SINGAPOREAN NOTICES TO MARINERS

II NOTICES TO MARINERS AND CHART CORRECTIONS

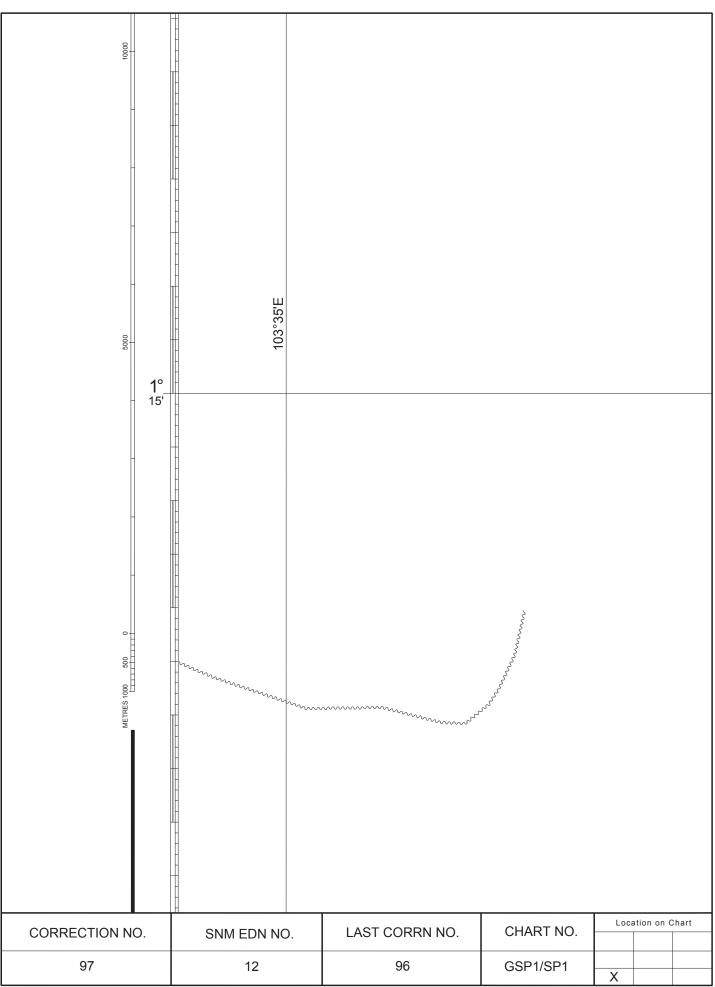
GSP1/SP1	8 Ed 17/01/24 Last NM 88/2024	(Maritime and Port Authority of Singapore)	*NM 95/2024
locaut	: Wk	1°16 20IN	402°E7 60'E
Insert	·• Wk	1°16·28'N	103°57·69'E
		(Maritime and Port Authority of Singapore)	*NM 96/2024
Insert	:: Obstn	1°15·05'N	103°41·47'E
		(Maritime and Port Authority of Singapore & Royal Malaysian Navy Notice No.06/114/2024)	*NM 97/2024
Insert	submarine cable, ~~~ , joining:	1°12·97'N	103°37·21'E
		1°12·56'N	103°37·12'E
		1°12·24'N	103°36·97'E
		1°12·10'N	103°36·88'E
		1°11·92'N	103°36·66'E
		1°11·93'N 1°12·07'N	103°36·44'E 103°35·89'E
		1°12·06'N	103°35·19'E
		1°12·35'N	103°34·33'E
		1°12·49'N	103°34·00'E
		(chart borde	
		(Maritime and Port Authority of Singapore &	
500	8 Ed 15/09/17 Last NM 70/2024	Royal Malaysian Navy Notice No.06/114/2024)	*NM 97/2024
Insert	submarine cable, ~~~ , joining:	1°12·97'N	103°37·21'E
		1°12·56'N	103°37·12'E
		1°12·10'N	103°36·88'E
		1°11·92'N	103°36·66'E
		1°12·06'N	103°35·19'E

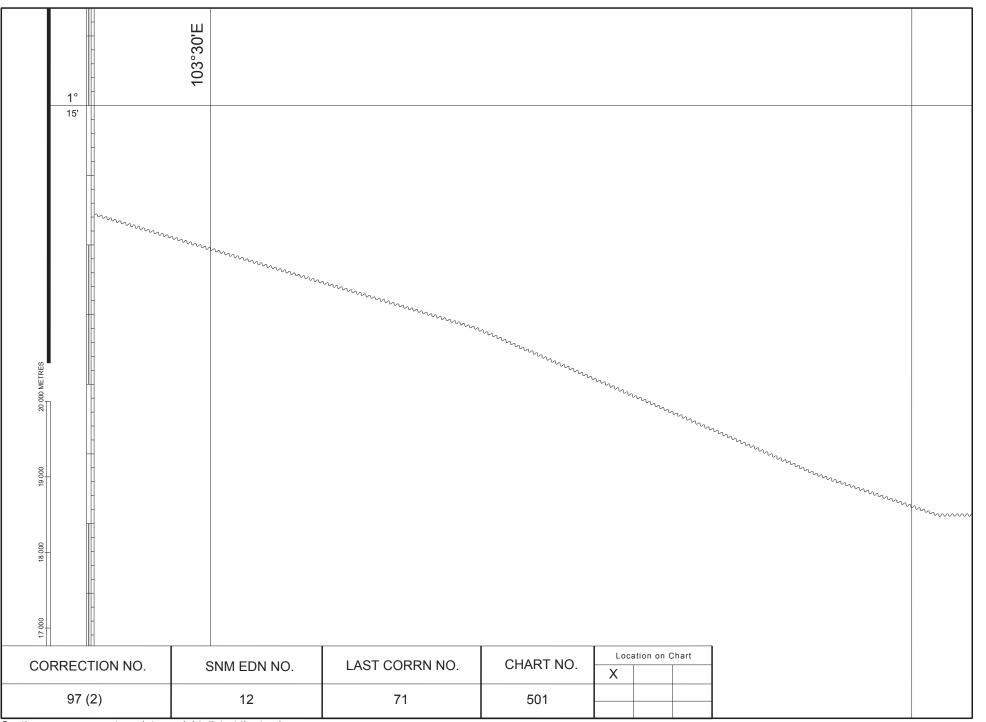
1°12·35'N	103°34·33'E
		1°14·39'N	103°28·62'E
		1°15·11'N	103°25·30'E
		1°16·50'N	103°23·83'E
		1°30·50'N (chart borde	103°10·68'E
		(chart borde	· · · · · · · · · · · · · · · · · · ·
		(Maritime and Port Authority of Singapore &	
501	7 Ed 01/09/15 Last NM 71/2024	Royal Malaysian Navy Notice No.06/114/2024)	*NM 97/2024
Insert	submarine cable, $\sim\!\!\!\sim$, joining:	1°12·97'N	103°37·21'E
		1°12·56'N	103°37·12'E
		1°12·10'N	103°36·88'E
		1°11·92'N	103°36·66'E
		1°11·93'N	103°36·44'E
		1°12·07'N	103°35·89'E
		1°12·06'N	103°35·19'E
		1°12·35'N	103°34·33'E
		1°13·40'N	103°31·90'E
		1°14·22'N	103°29·17'E
		(chart borde	er)

Block for Chart No 502

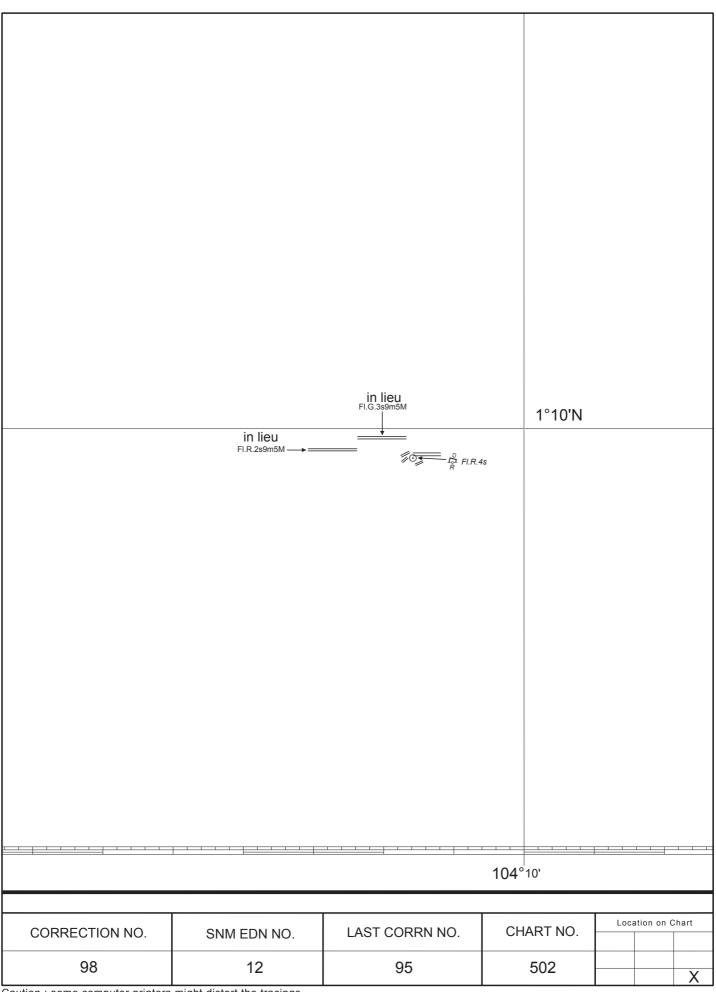
502	9 Ed 15/10/21 Last NM 87/2024	(Maritime and Port Authority of Singapore)	*NM 95/2024
Insert	:43: WK	1°16·28'N	103°57·69'E
	••••	(Admiralty Notice No. 28/2317/2023)	NM 98/2024
Insert	the accompanying block, centred on:	1°09·85'N	104°13·33'E
	FI.R.4s	1°09·79'N	104°09·21'E
Amend	light to, Fl.R.2s9m5M	1°09·76'N	104°08·85'E
	light to, Fl.G.3s9m5M	1°09·81'N	104°08·89'E

-		
Delete	FI.R.2s	1°09·81'N	104°09·15'E
		(Royal Malaysian Navy Notice No.10/206/2024)	NM 99/2024
Insert	♣ FI(2)G.10s, E2	1°19·45'N	104°08·37'E
Delete	♣ FI(2)G.6s, E2	1°19·47'N	104°08·32'E
503	5 Ed 15/08/14 Last NM 82/2024	(Admiralty Notice No. 28/2317/2023)	NM 98/2024
Insert	the accompanying block, centred on:	1°09·84'N	104°13·35'E
		(Maritime and Port Authority of Singapore)	*NM 100/2024
Delete	♣ HB 1	1°19·74'N	104°24·26'E
		(Royal Malaysian Navy Notice No.10/205/2024)	NM 101/2024
Delete	()	1°20·92'N	104°18·50'E
200	4 Ed 01/09/15 Last NM 89/2024	(Royal Malaysian Navy Notice No.06/114/2024)	NM 97/2024
Insert	submarine cable, ~~~ , joining:	(chart borde 2°03·91'N	er) 102°09·91'E
		2°16·99'N	101°53·45'E
		2°32·26'N	101°34·57'E
		2°35·20'N	101°32·06'E
		2°35·14'N	101°31·59'E
		2°50·25'N	101°04·18'E
		2°59·68'N 3°01·47'N	100°56·46'E
		3°01·47N 3°03·65'N	100°53·97'E 100°47·16'E
		3°11·99'N	100°47°10°L
		(chart borde

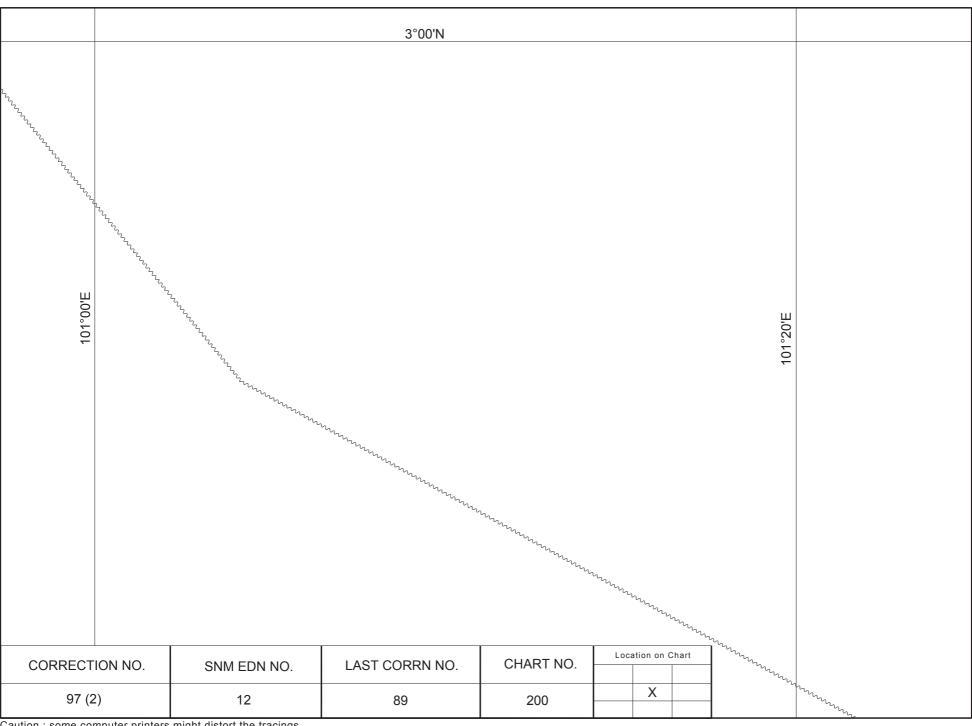
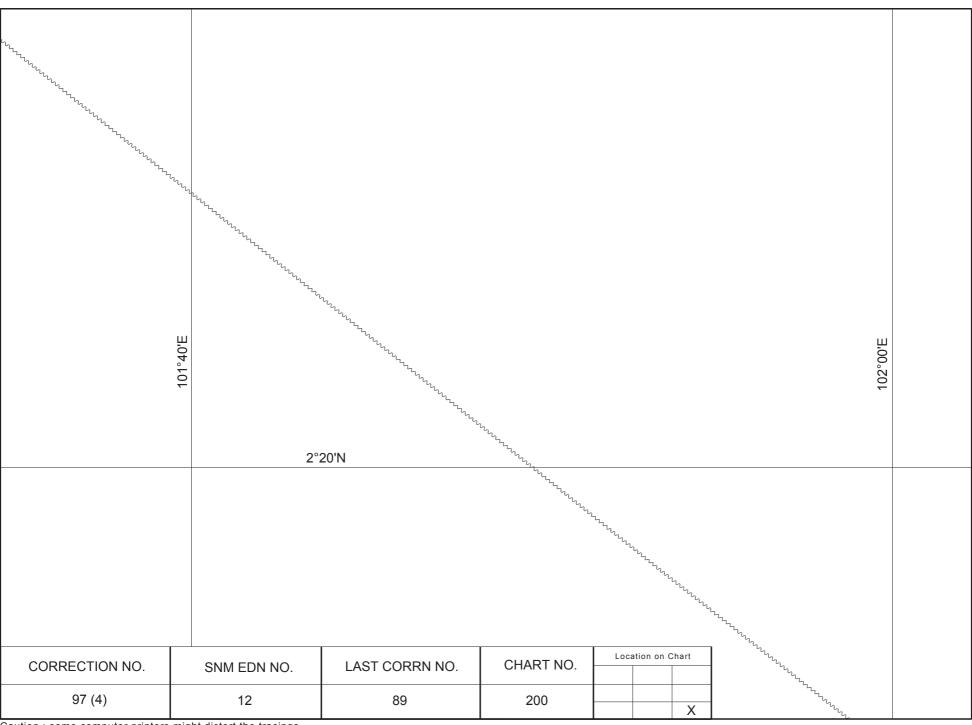
(Royal Malaysian Navy Notice No.10/200/2024)	NM 102/2024
Amend	light to, FI(4)20s43m16M	2°53·31'N

Block for Chart No 201

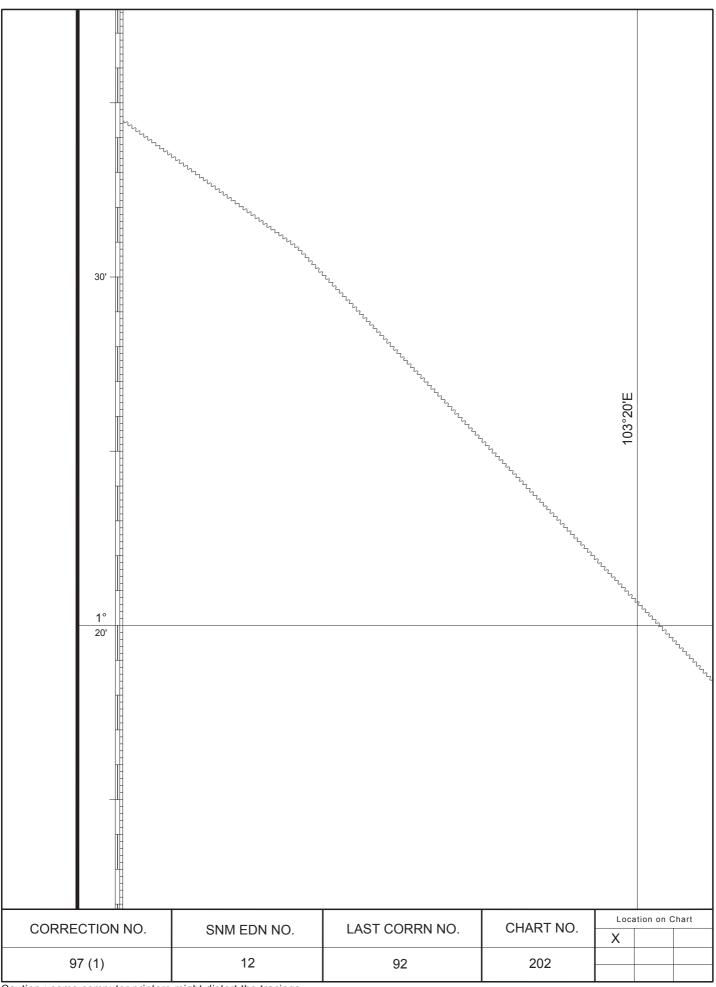
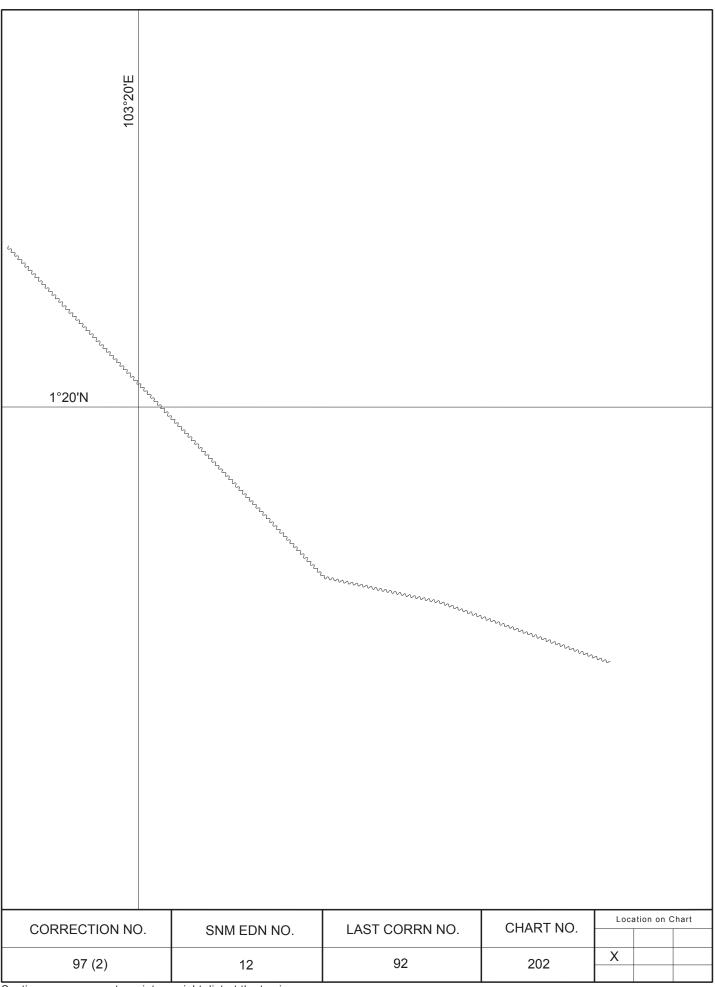
201	6 Ed 15/09/17 Last NM 91/2024	(Royal Malaysian Navy Notice No.06/114/2024)	NM 97/2024
Insert	submarine cable, ~~, joining:	(chart bord	er)
	, ,,	2°16·99'N	101°53·45'E
		2°03·91'N	102°09·91'E
		1°56·63'N	102°19·00'E
		1°38·07'N	103°00·32'E
		1°34·53'N	103°05·34'E
		1°30·85'N	103°10·31'E
		1°20·10'N	103°20·29'E
		1°15·11'N	103°25·30'E
		1°14·86'N	103°26·45'E
		(chart bord	er)
		(Royal Malaysian Navy Notice No.09/180/2024)	NM 103/2024
Insert	the accompanying block, centred on:	2°04·44'N	102°19·14'E
		(Maritime and Port Authority of Singapore &	
202	8 Ed 15/09/16 Last NM 92/2024	Royal Malaysian Navy Notice No.06/114/2024)	*NM 97/2024
Insert	submarine cable, $\sim \sim$, joining:	1°12·97'N	103°37·21'E
		1°12·56'N	103°37·12'E
		1°12·10'N	103°36·88'E
		1°11·92'N	103°36·66'E
		1°12·06'N	103°35·19'E
		1°12·35'N	103°34·33'E
		1°14·39'N	103°28·62'E
		1°15·11'N	103°25·30'E
		1°30·85'N	103°10·31'E
		1°34·50'N	103°05·34'E
		(chart bord	er)

(Royal Malaysian Navy Notice No.10/205/2024)	NM 101/2024
Delete	******	1°20·92'N	104°18·50'E
